Re: Response to BETA & MassDEP Comments - Notice of Intent Peer Review #3
444 East Central Street, Franklin MA (DEP File No. 159-1320)

BETA Comments & Responses

SIGN TYPE 1
 "NATIVE PLANTINGS, MOW ONLY
 ONCE PER YEAR IN LATE FALL"
 (COMMENT W1:5)

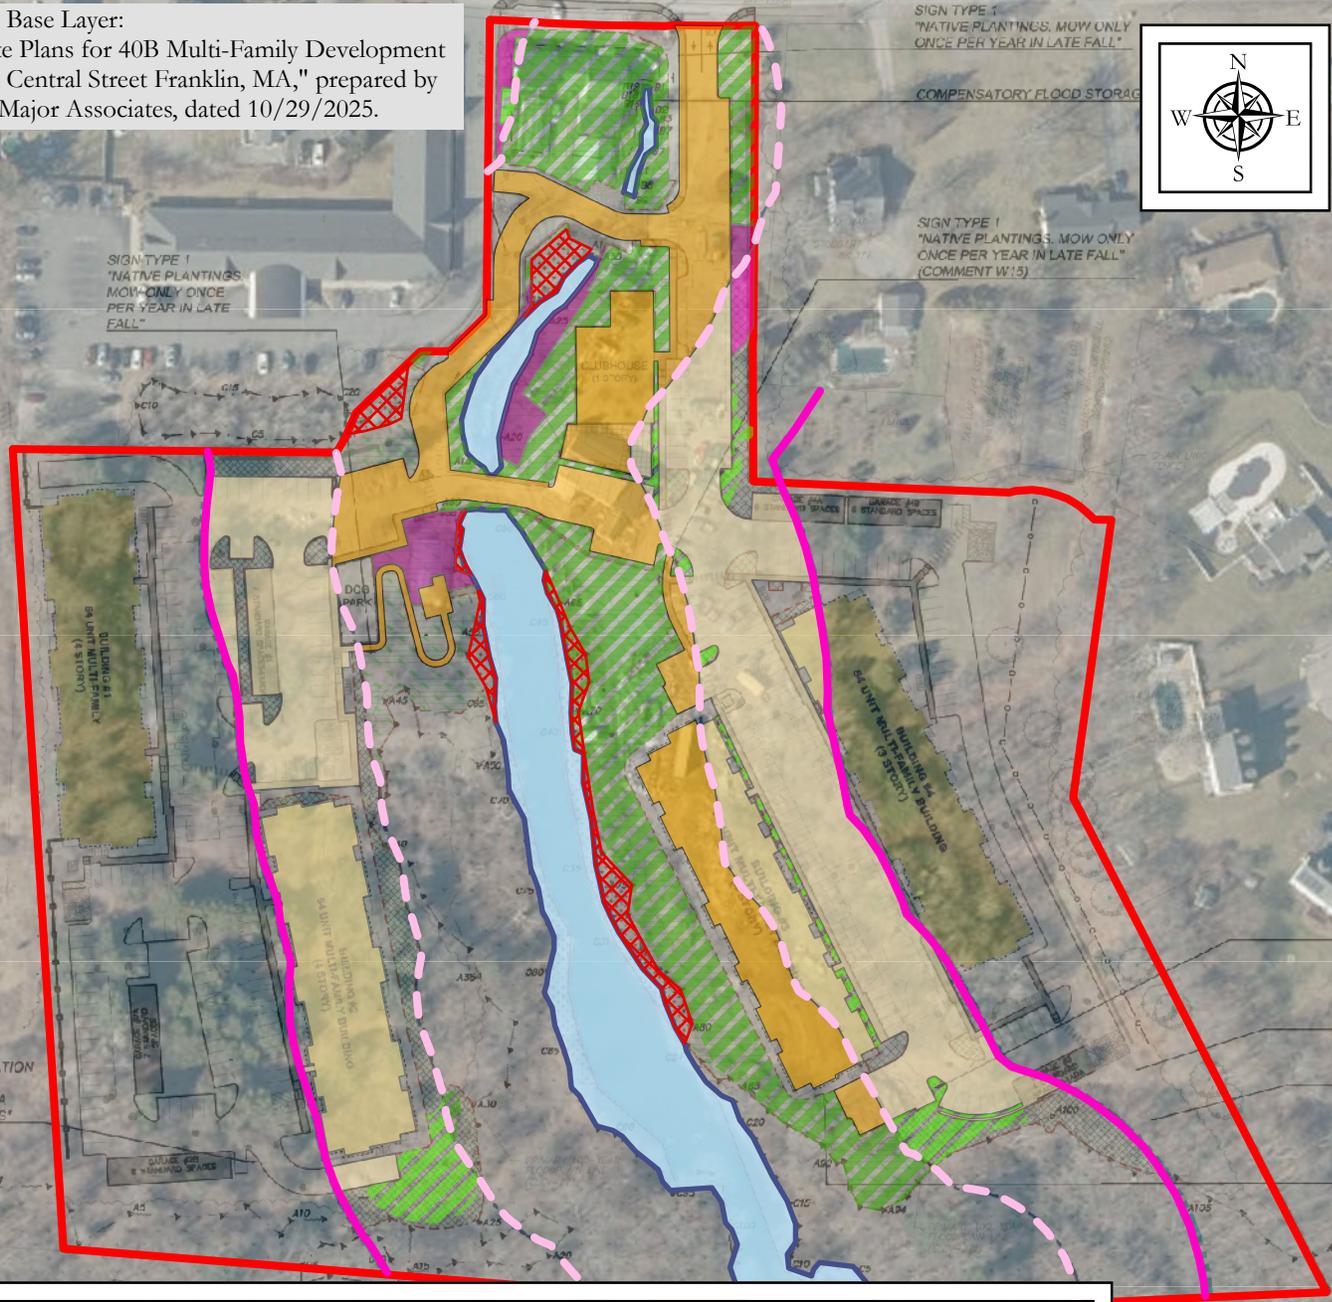
It is recommended that areas subject to native plantings/restoration be mowed only once per year during late fall; this could be included as a Special Condition. If so, it is recommended that signage be required to demarcate these areas and this requirement in the field.

Comment addressed. The Applicant has provided proposed signage for areas planted with native vegetation that will state "Native plantings. Mow only once per year in late fall". BETA defers to the Commission on the approval of this signage.

The Restoration, Replication and Mitigation Plan has been updated to stipulate that mowing of naturalized areas is not proposed. Rather, mechanical removal in these areas should be completed by targeted cutting performed by hand-operated tools or equipment. Signage indicating that mowing is only intended to occur once per year in late fall has been added to the landscape plan sheets.
